Moorebank Avenue Realignment (SSI-10053)
Urban Design and Landscape Plan with revised Appendix A
Landscape Design Plans Conditions E61-E64

RE: Moorebank Avenue Realignment (SSI-10053) Urban Design and Landscape Plan - Updated Landscape Plans

Table 1 - Landscape Plans #3 design changes

Project	MOOREBANK AVENUE REALIGNMENT WORKS (MARW)
Title	GENERAL ARRANGEMENT PLAN SHEET 2 OF 14 LANDSCAPE DESIGN

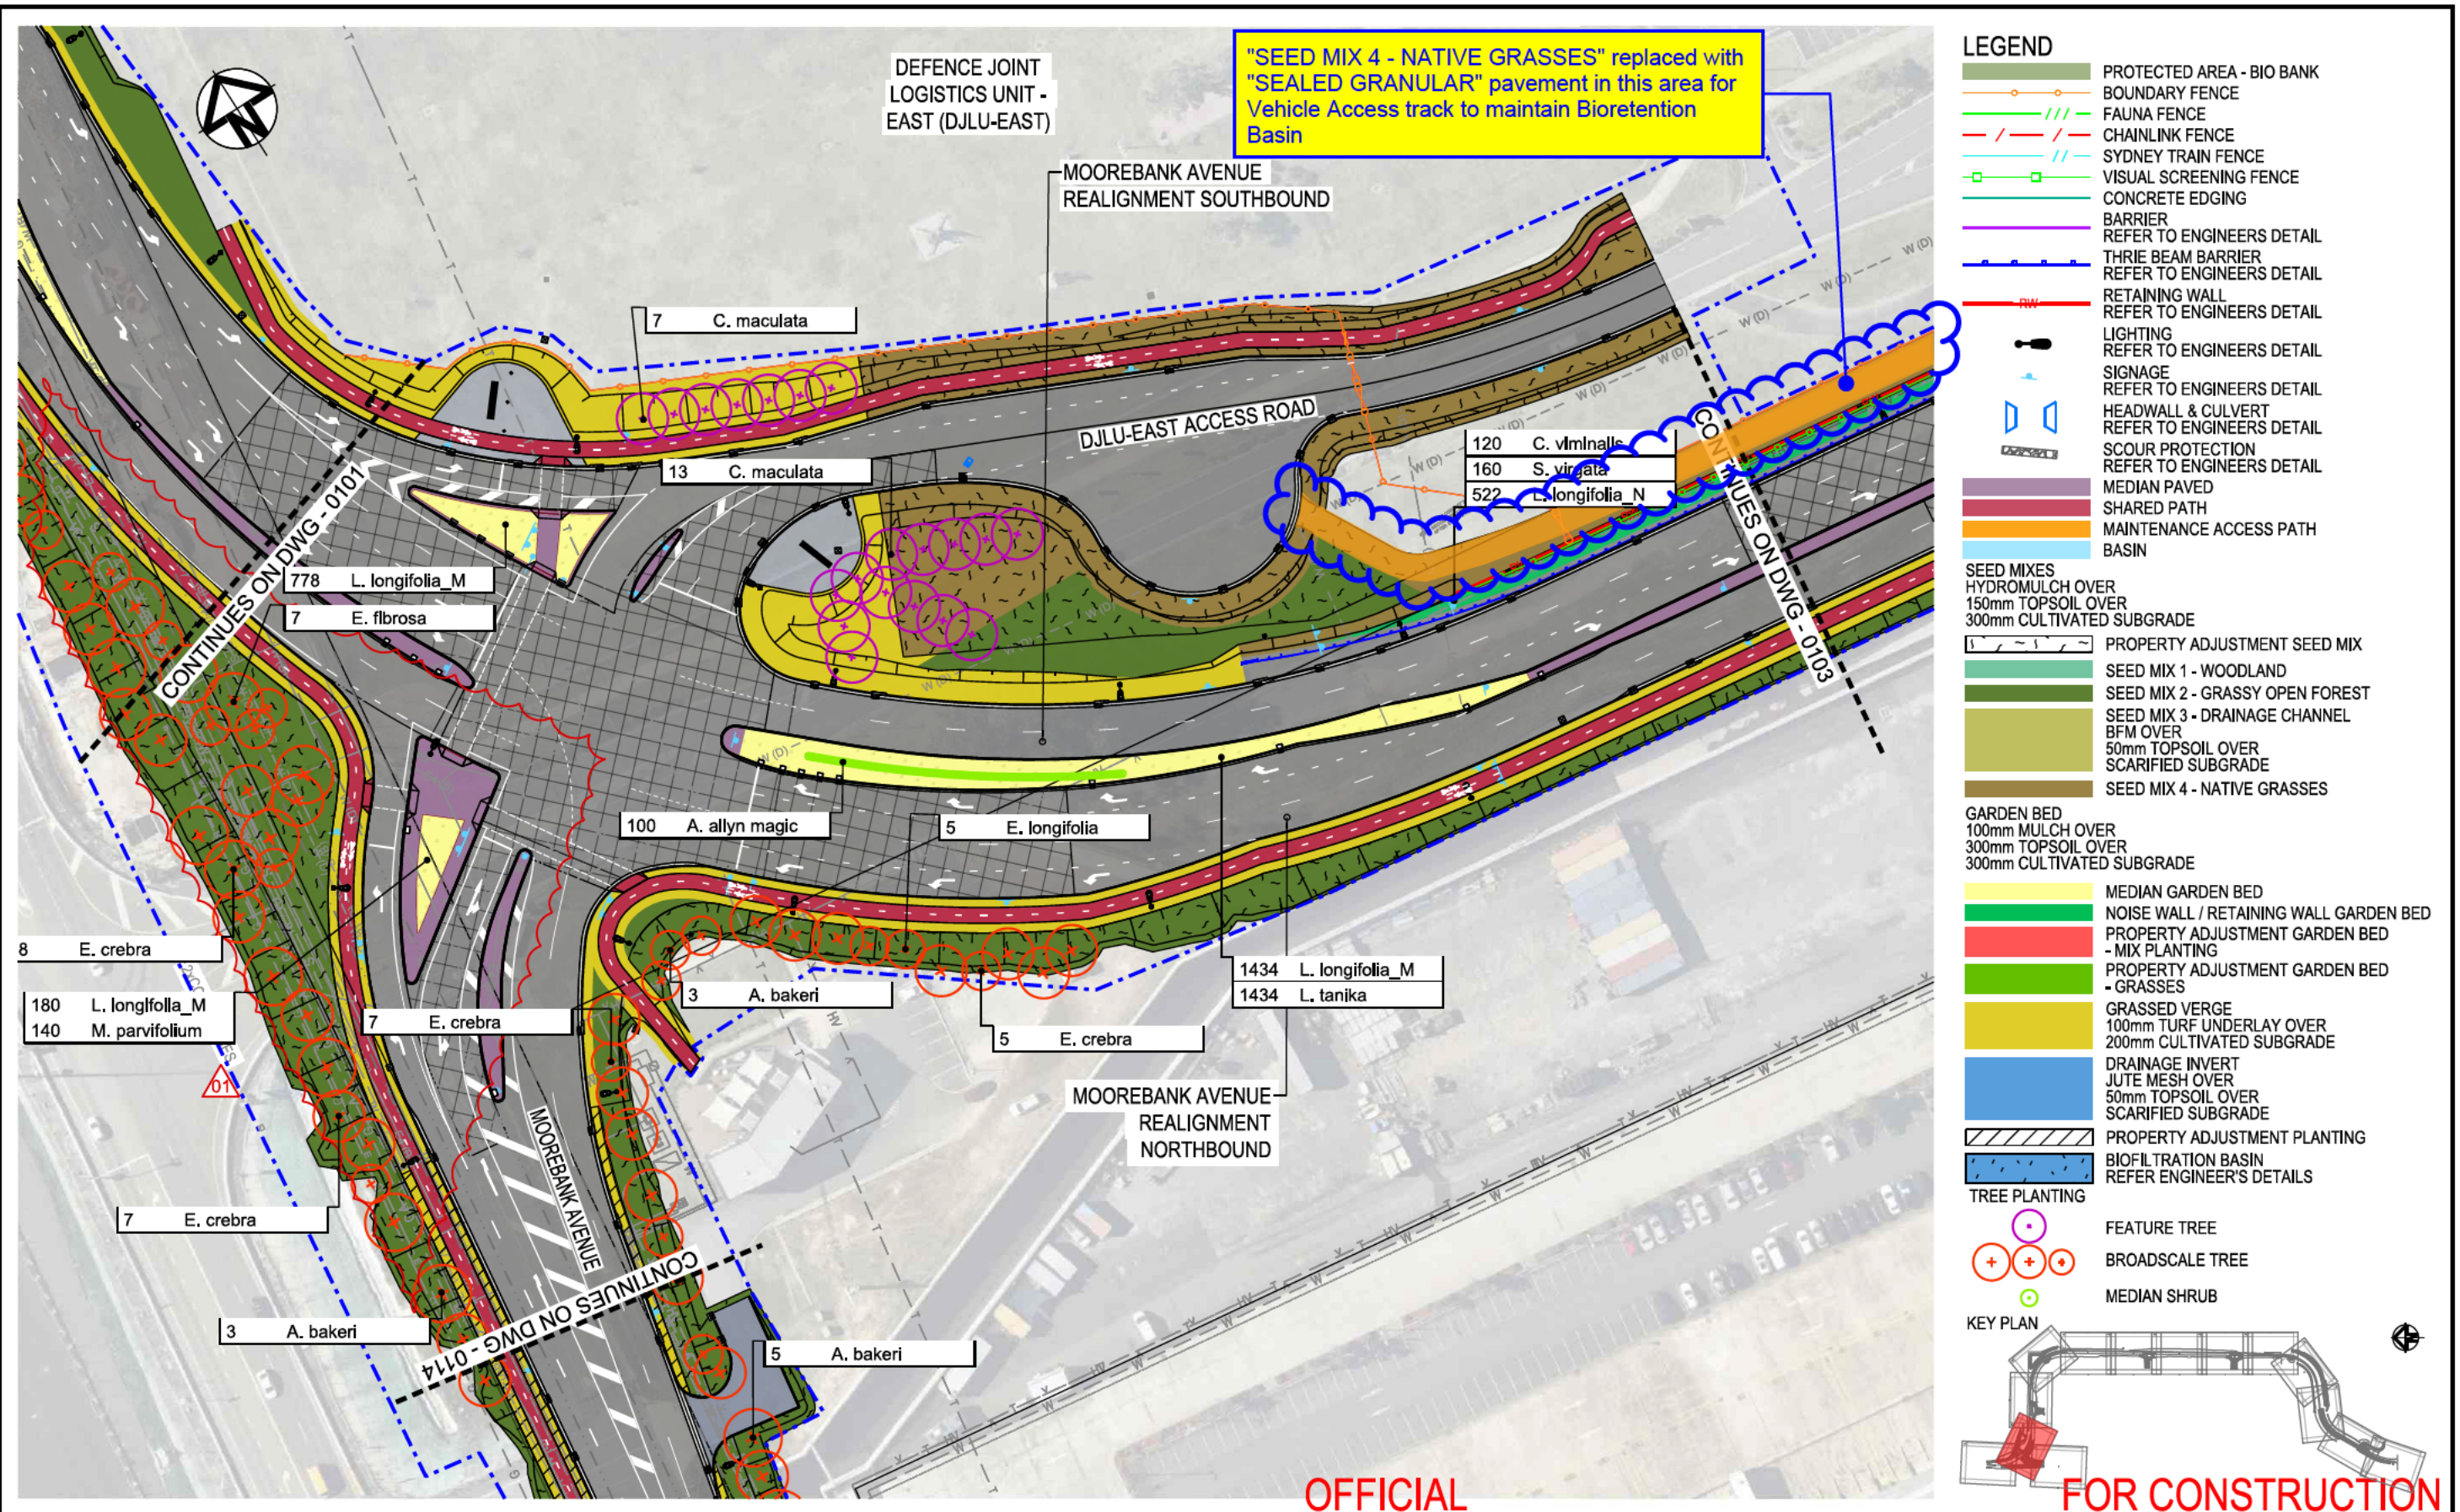
Element	Design change	Justification	Relevant drawings
Maintenance access track	Grassed surface changed to sealed pavement.	Required for all weather access to enable TfNSW basin maintenance.	DWG-0102 - 0104
Retaining wall	Retaining wall (concrete) added to edge of maintenance access track (previously no retaining wall). Range from 0.4 – 0.8 metres above ground level, with landscape buffer.	- Compliance required with grading design to enable drainage to remain within the MAR – i.e. drain to onsite basin not DoD site. - Safety for vehicles utilising the track. - Retain the TfNSW gazettal boundary (i.e. not encroach into DoD lands).	DWG-0103 - 0104
Interior basin material	Biofiltration ('teardrop') basin interior previously incorrectly identified as 'median paved' rectified to include 'biofiltration vegetation'. Detention ('rectangular') basin interior previously incorrectly identified as 'medium paved' rectified to include drainage vegetation.	- Previous drafting error. - Biofiltration vegetation required for the functionality (filtration) of the basin.	DWG- 0104

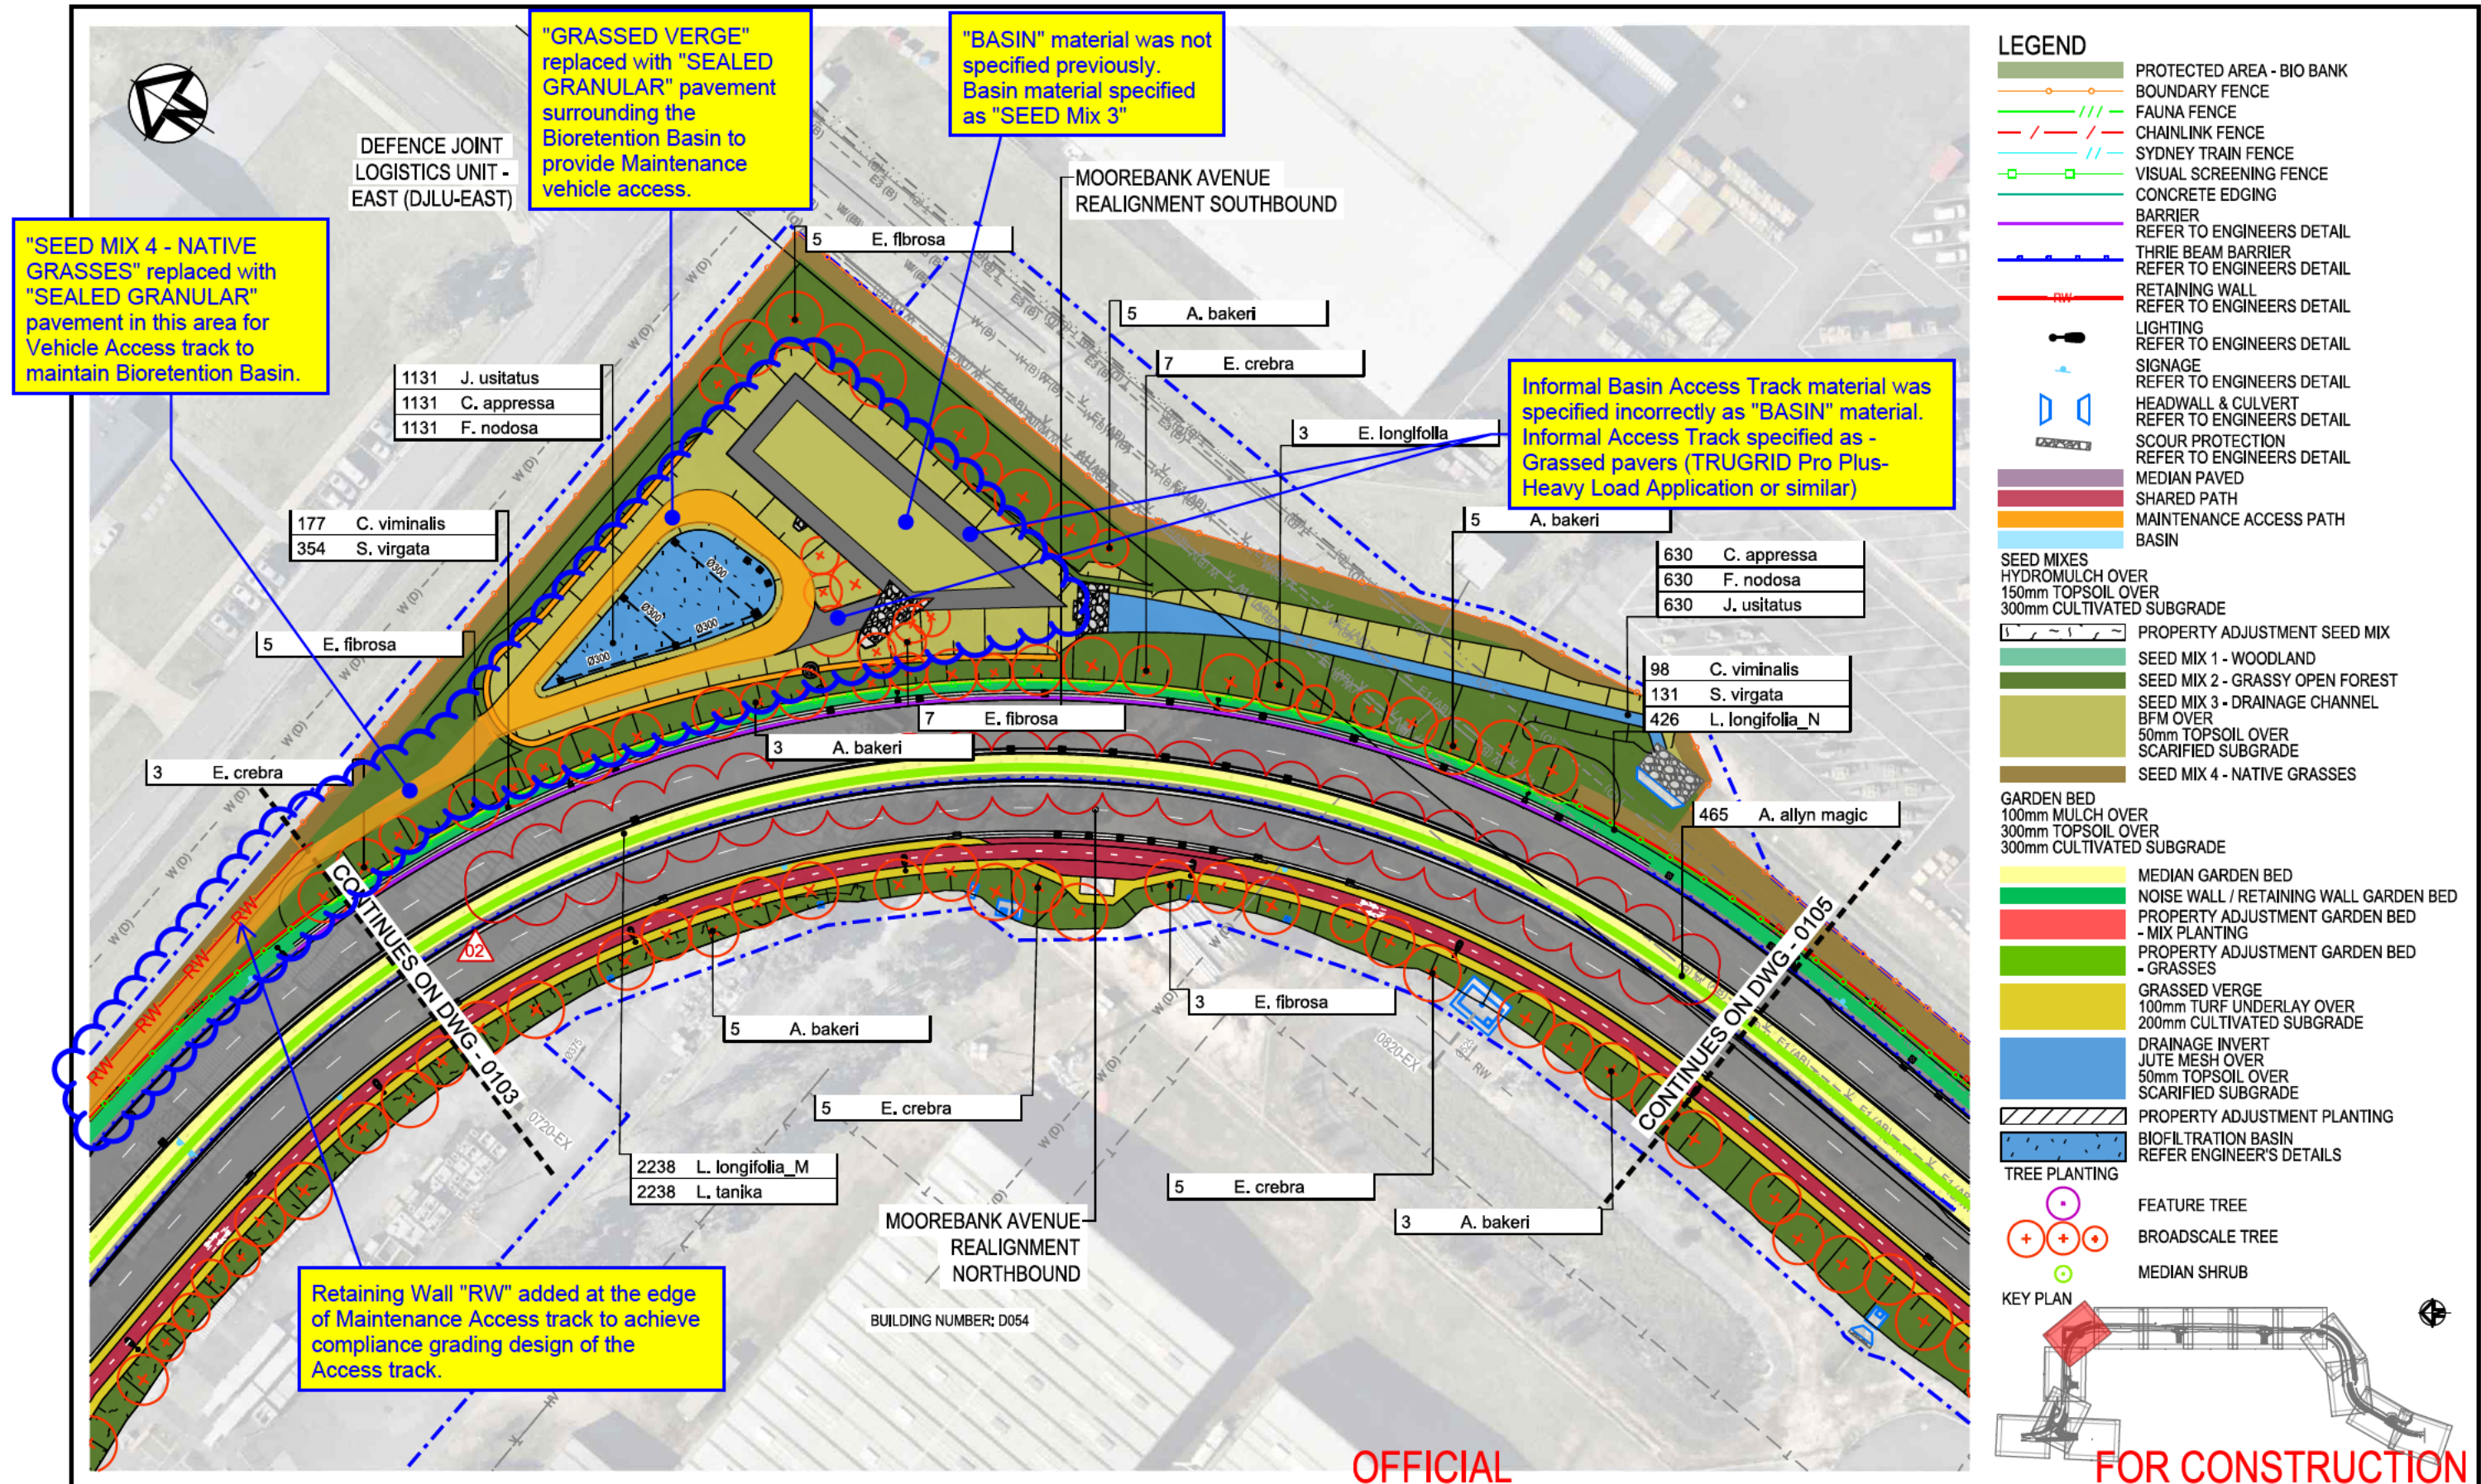
Basin access track	Basin access track previously incorrectly identified as 'basin' rectified to be grassed pavers.	- Previous drafting error. - Required for all weather access to enable TfNSW basin maintenance.	DWG- 0104
